AIR STRUT - TOP PLATE

FIGURE 1

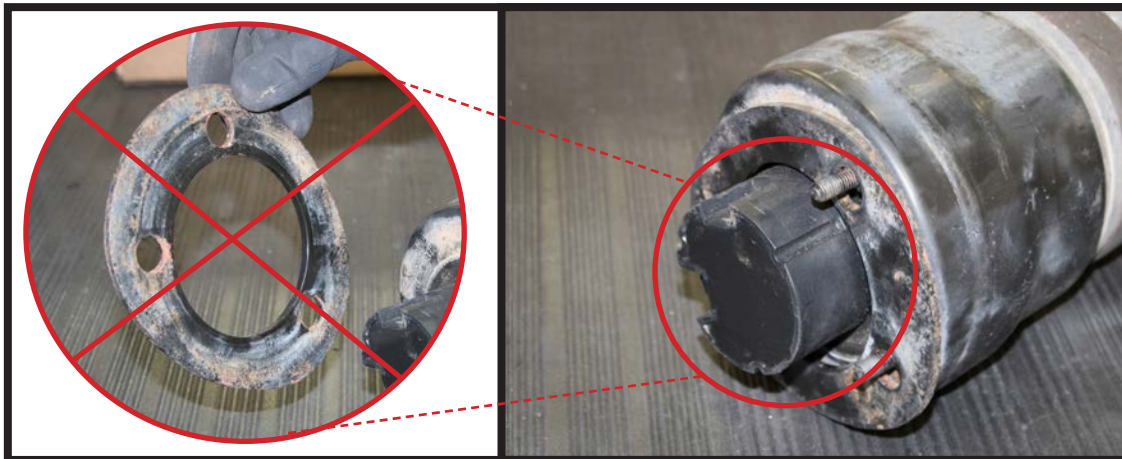
ARNOTT'S TOP MOUNT DESIGN INCORPORATES FLUSH MOUNTED FASTENERS, AS OPPOSED TO THE SURFACE MOUNTED FASTENERS ON THE OE ASSEMBLY WHICH REQUIRED THE USE OF A SHIM PLATE TO LEVEL THE MOUNTING SURFACE.

1. DO NOT REUSE FACTORY TOP PLATE. (FIGURE 1)
